City of Santa Fe, New Mexico

Attachment A Conditions of Approval and Technical Corrections

Case #2025-11753 & 2025-11756. 1750 and 1802 Cerrillos Rd, 3 RD Berry Ave, and 1361 Fourth St Development Plan and Special Use Permit. B Constructiv LLC and Sommer Karnes & Associates LLP, "Agents" for Amatren, LLC, Owner and Applicant ("Applicant"), request approval of a Development Plan and Special Use Permit to redevelop the properties listed above into a self-storage facility with community office and gathering spaces. The property is zoned C-2 (General Commercial) and is within the Suburban Archaeological Review District. (Alexa Hempel, Case Manager, anhempel@santafenm.gov).

Illustration 14-9.2-1: **Street** Types Design

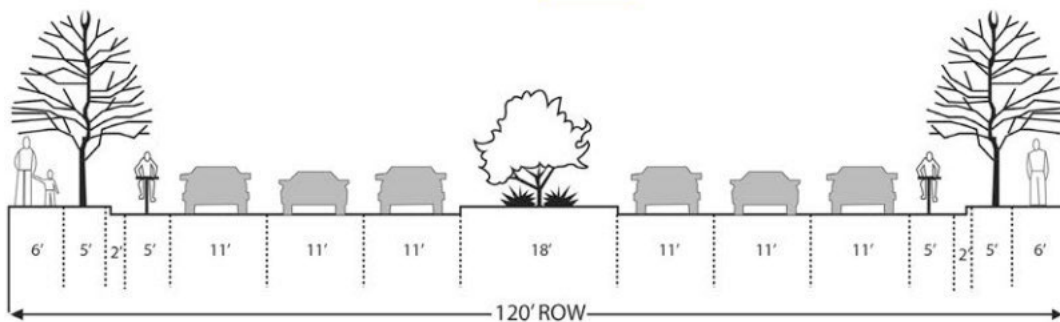
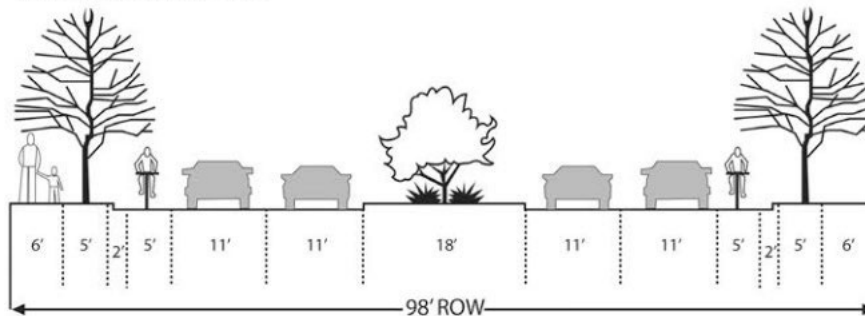
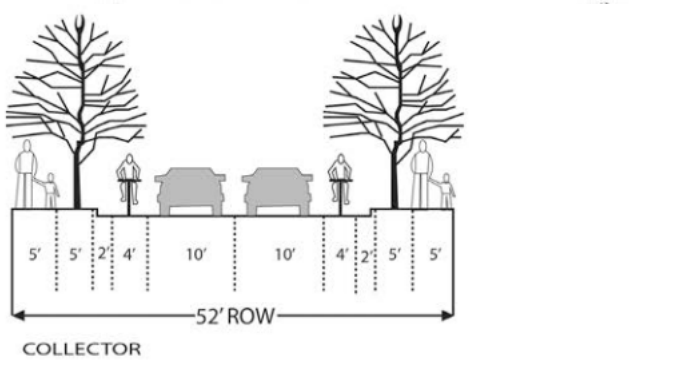
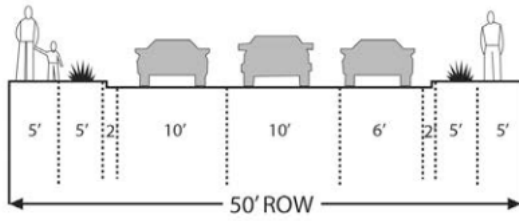
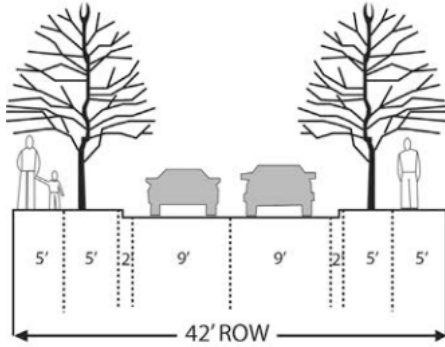
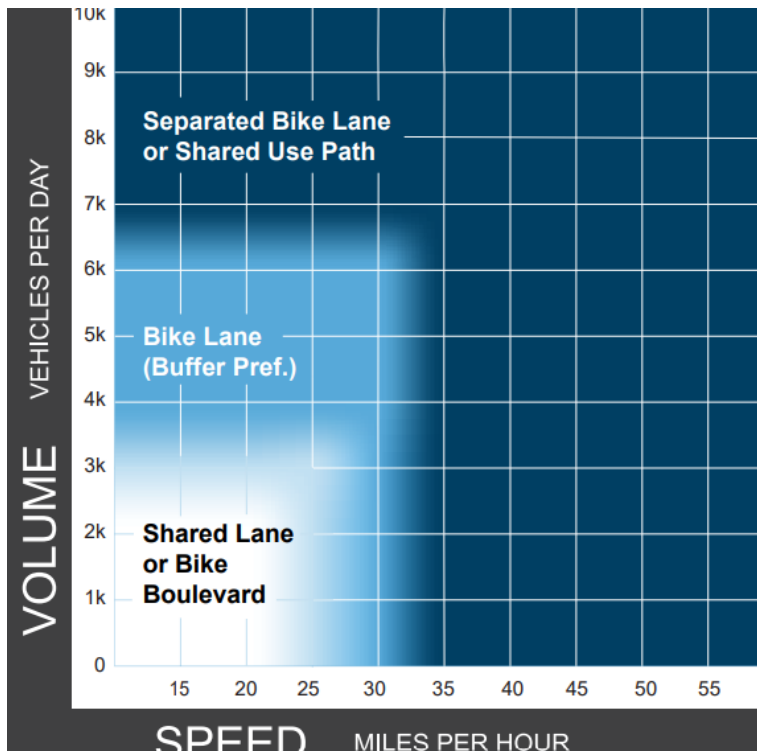
- f. Must bring Existing Corner curb ramps to ADA compliance.
- 5. MPO**
- a. Sidewalk should align with Cerrillos Road Plan specs and city street design standards which require 5' landscape buffer between street and pedestrian path (See comments on plans for detail). Sidewalk width should be at least 6', but also made as wide as possible on Cerrillos. FHWA and AASHTO guidance support a separated bike facility given the vehicle speeds and volumes here. By expanding the sidewalk to the minimum for a shared use path (10') this would better align with federal guidance.

See City Street Standards below for sidewalk and landscaping buffer requirements

SITE PLAN

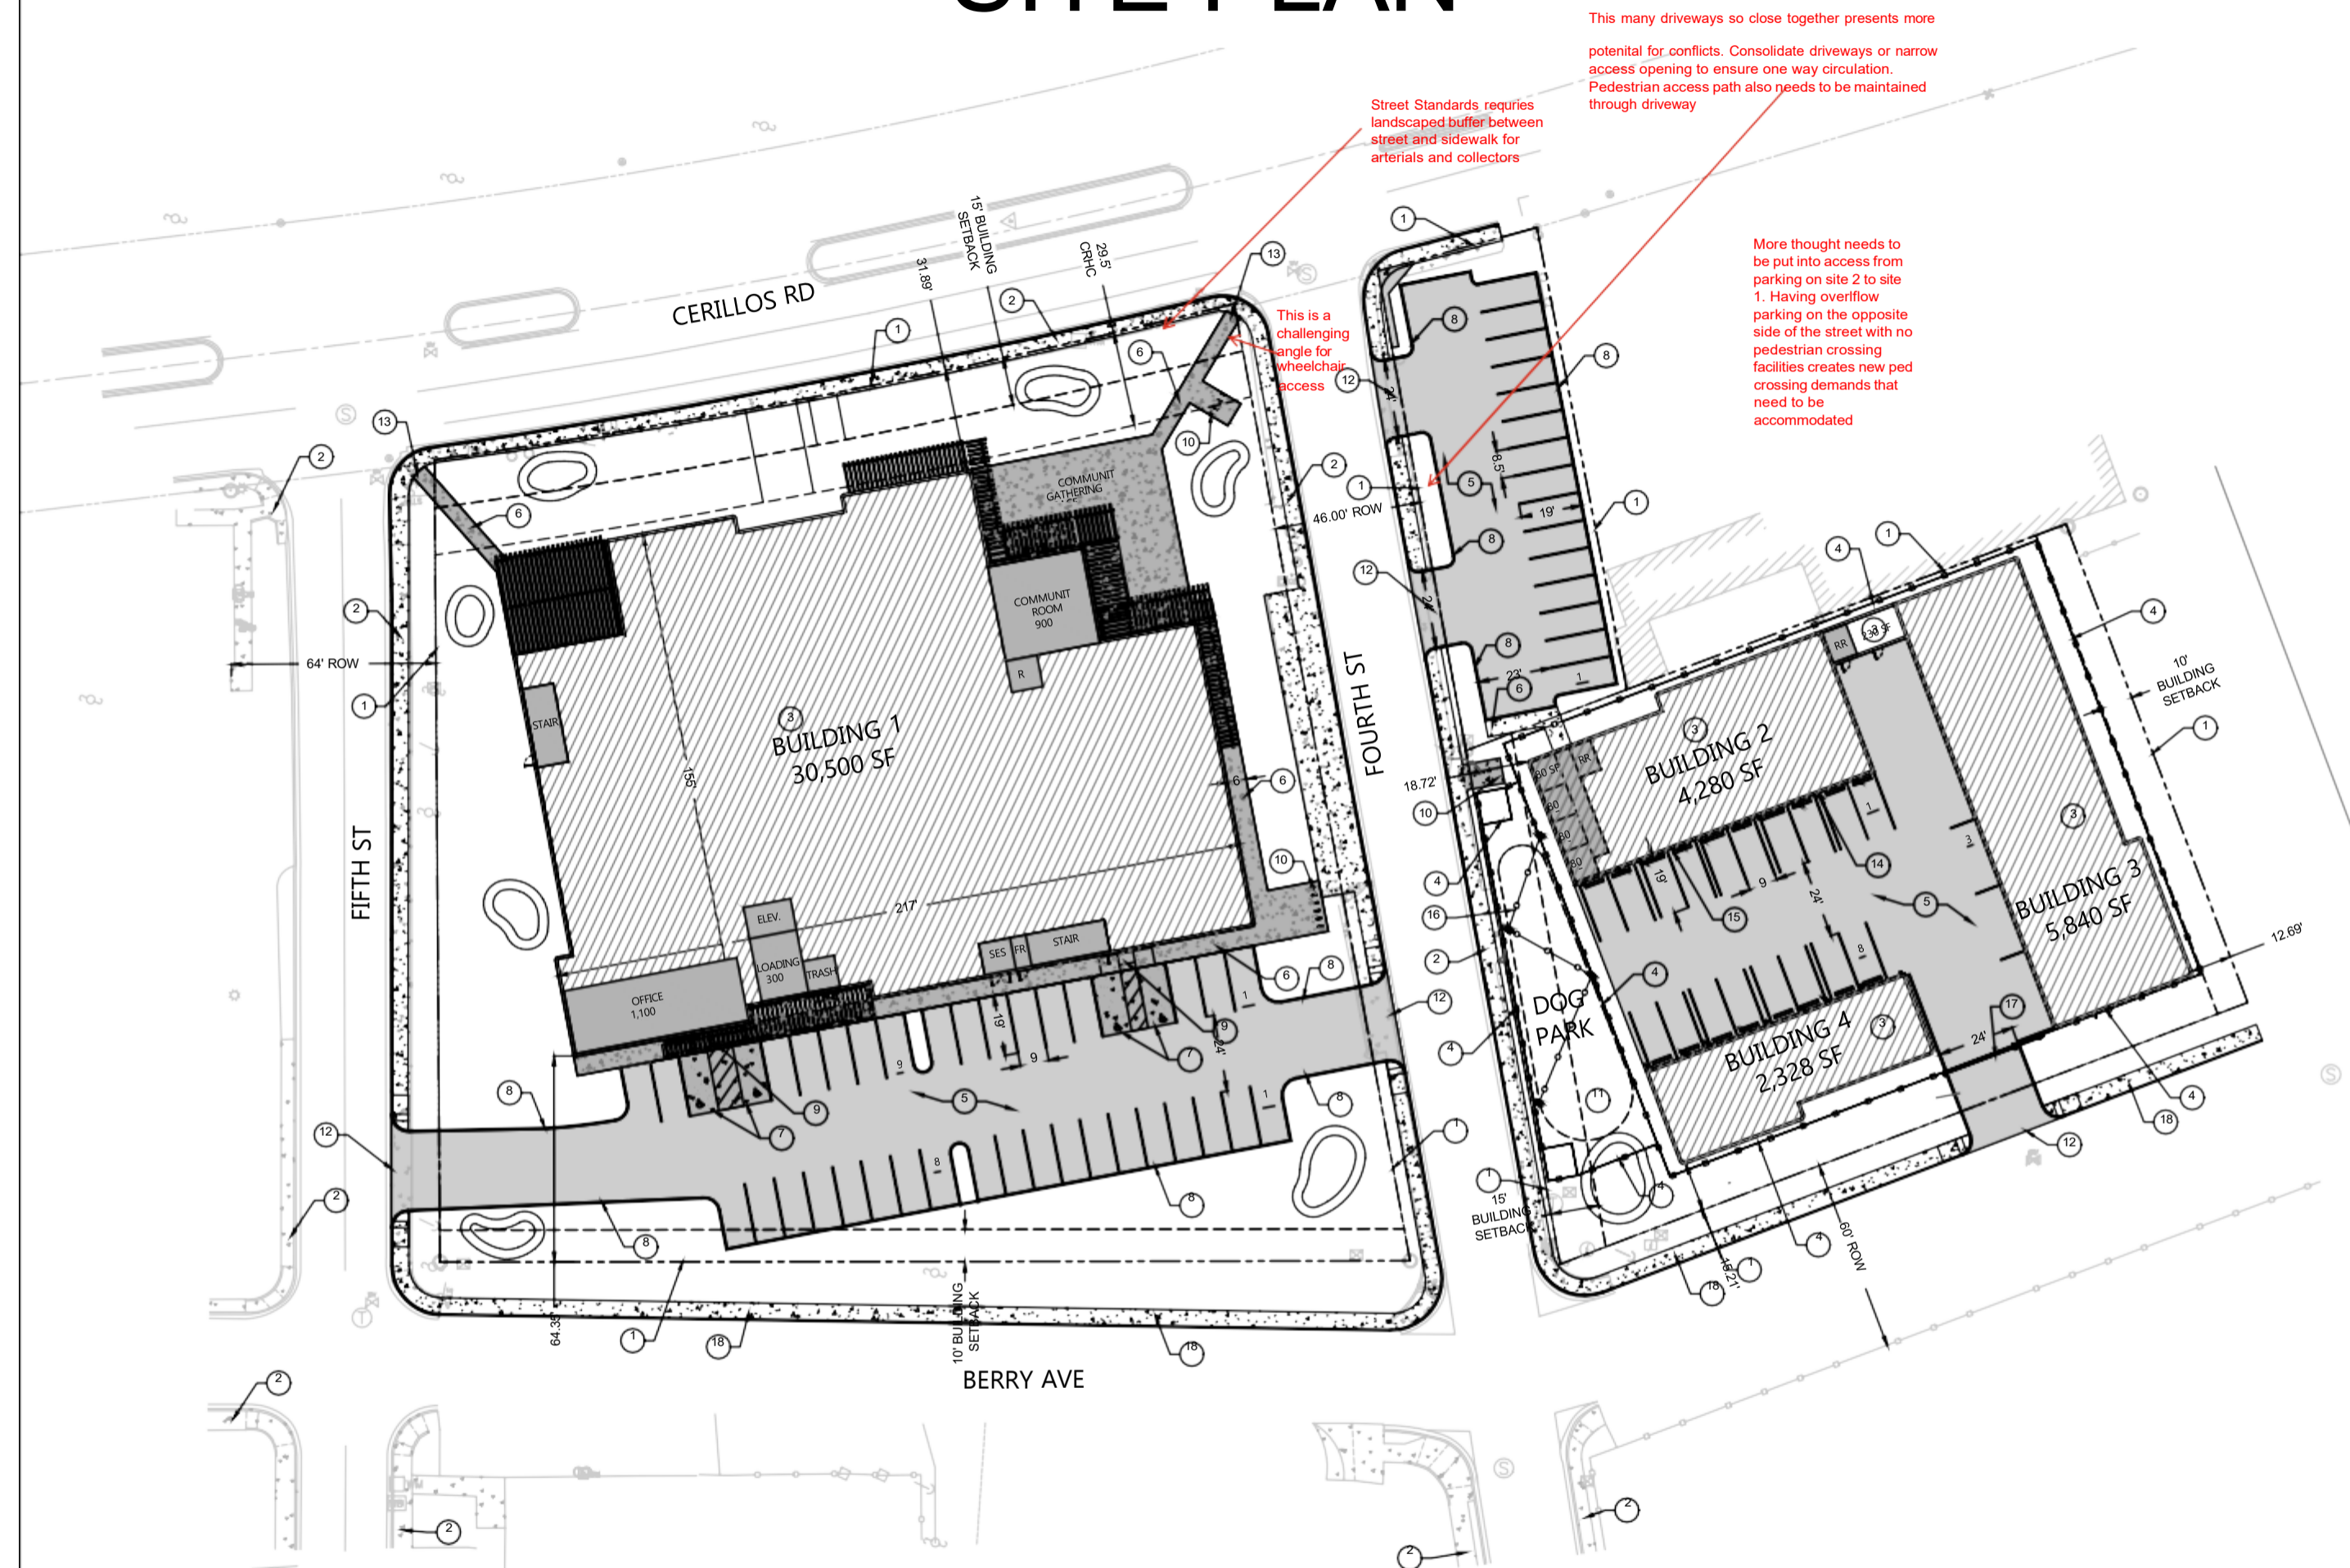
- e. Fencing oddly crosses retention pond (C-201)
 - f. The dog park should be designed and constructed to capture the first flush of surface runoff in order to reduce water quality impacts. As currently depicted, the grading plan does not direct runoff in a manner that would enable the pond to function as intended (sheet -304)

EMPIRE SELF STORAGE SIGNING AND STRIPING - ADA PLAN

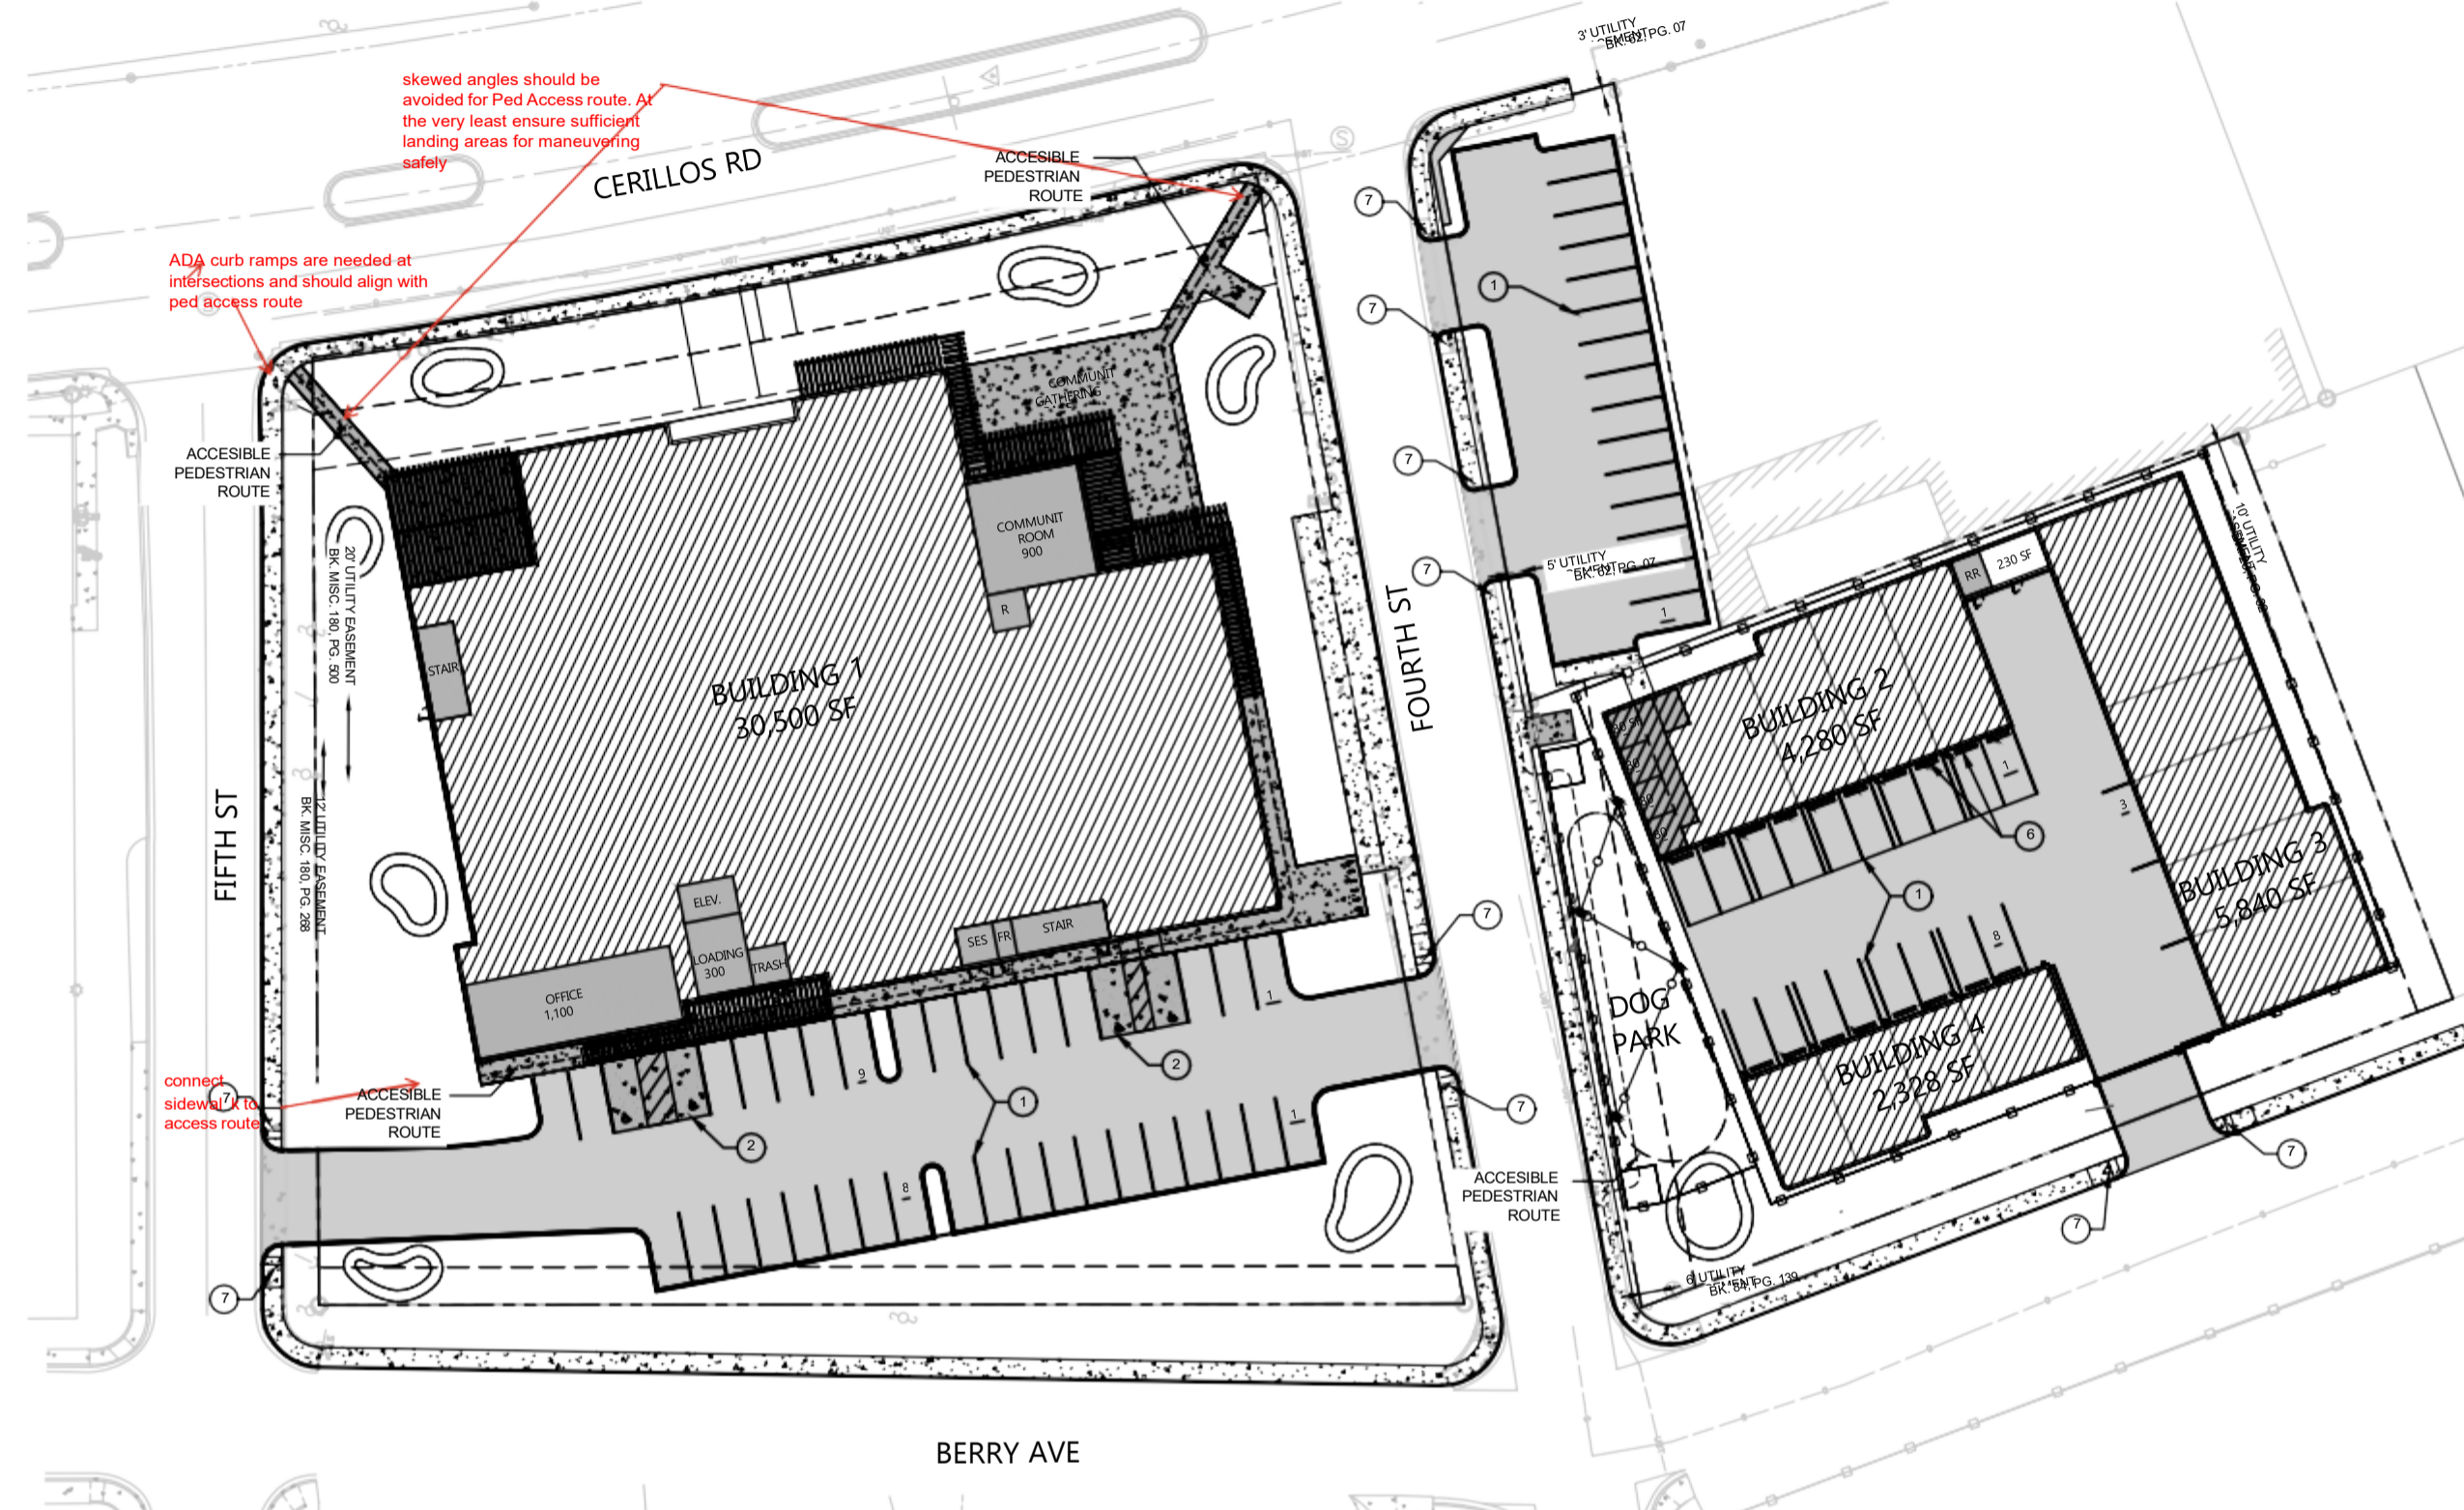
- e. Make changes as shown in redlines on plans (attached)
- 6. Traffic**
- a. See attached letter from Wilson & Company dated 2/20/26 certifying its concurrence with the developer's "Initial Traffic Assessment" (ITA).
